Work Order ID 114057***114057***

Item Name: Square Tube

Draw Nbr	Revision Nbr
B67-43001	C

WORK ORDER NON-CONFORMANCE / UPDATE

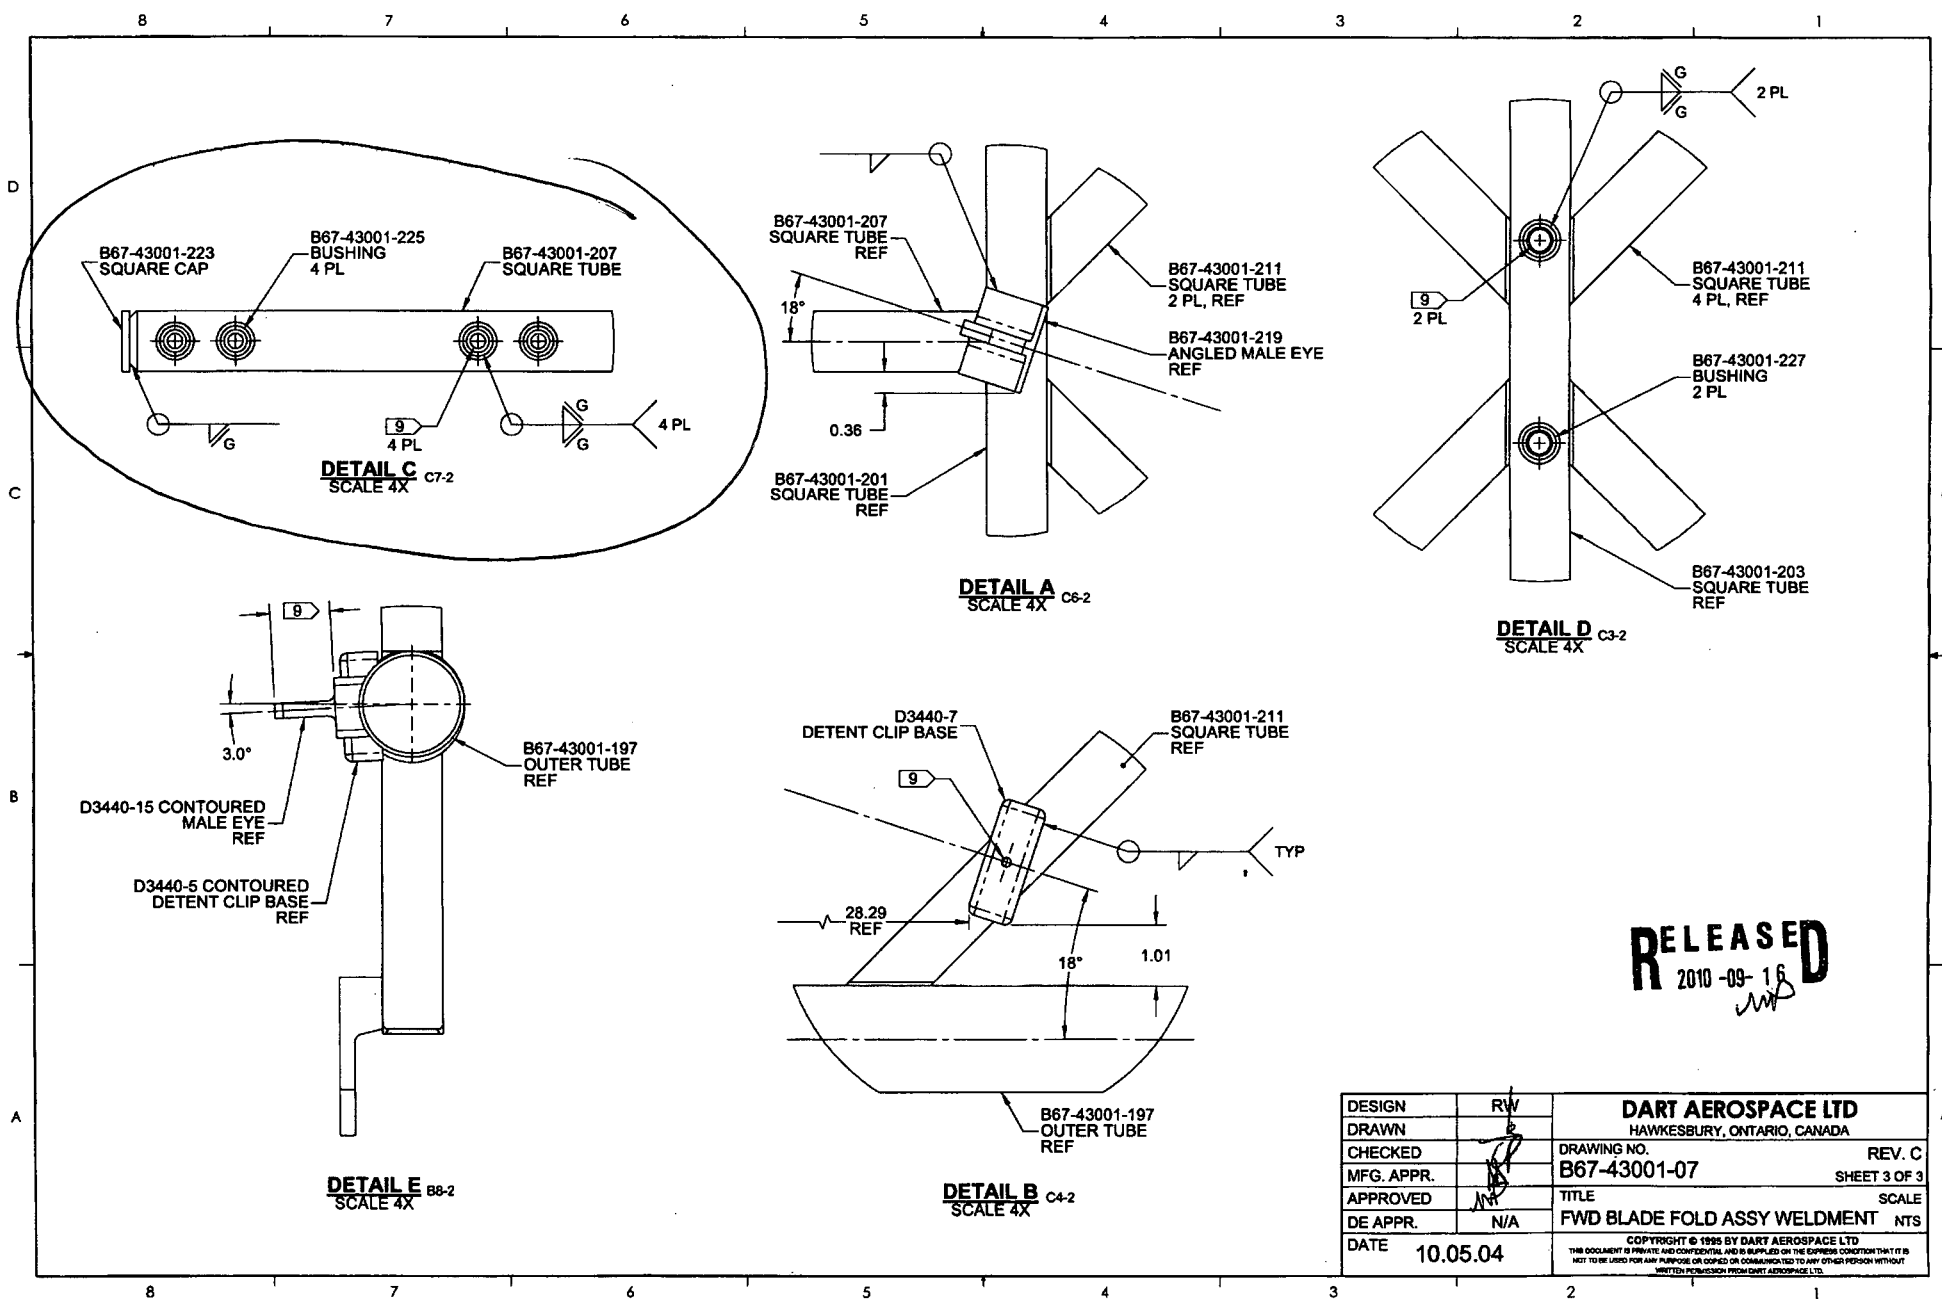
Root Cause	Date	Step	Qty	Description of work order update or non-conformance	Initial Chief Eng	Action Description	Sign & Date	Verification	QC Inspector
Design				STEP MISSING on W/O + DWG		WELD B67-43001-223			
Doc/Data				TO EFFECTIVELY MFG PART.		END CAP; GTY (17).			
Equip/Tooling						P/N: 547504-2 6			
Handling/Pre	14.03.11	ADD STEP 120	6	WELDING OF B67-43001-223	14.03.11	WELD B67-43001-225	14.03.13	DAS 27 989 14/3/19	DAS 16 9-89 14/03/14
Material				END CAP + B67-43001-225		BUSHING; GTY (27).			
Operator				BUSHING PER DWG		P/N: B112762-2 24	PD		
Offset/Setup				B67-43001-07 REQ'D.		ALUMINUM ROD P/N: H126325			
Process						GRIND FLUSH.			
Supplier									
Training									
Transport									
Unapproved
